Register Reference: SDZ22A/0018 AI

Construction of a mixed-use development comprising 594 apartments, office floorspace, 4 retail units, a creche and urban square in the Clonburris Development Areas CUCS3 & CSWS3 of the Clonburris SDZ Planning Scheme.

### **Roads Related Additional Information Requested by SDCC:**

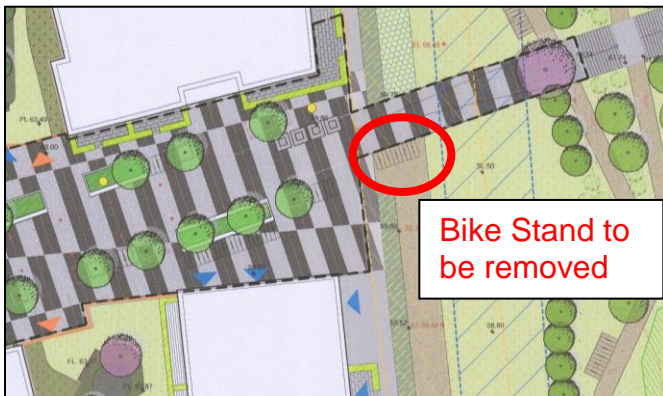
The bicycle stands located at the Eastern end of the Main Street Axis (see drawing below) should be removed as they would obstruct pedestrian movement along the outer pedestrian route as well as possible emergency access.

1. The bicycle stands located on the pedestrian path at the Eastern end of the Main Street Axis should be removed as they would obstruct pedestrian movement along the outer pedestrian route as well as possible emergency access.
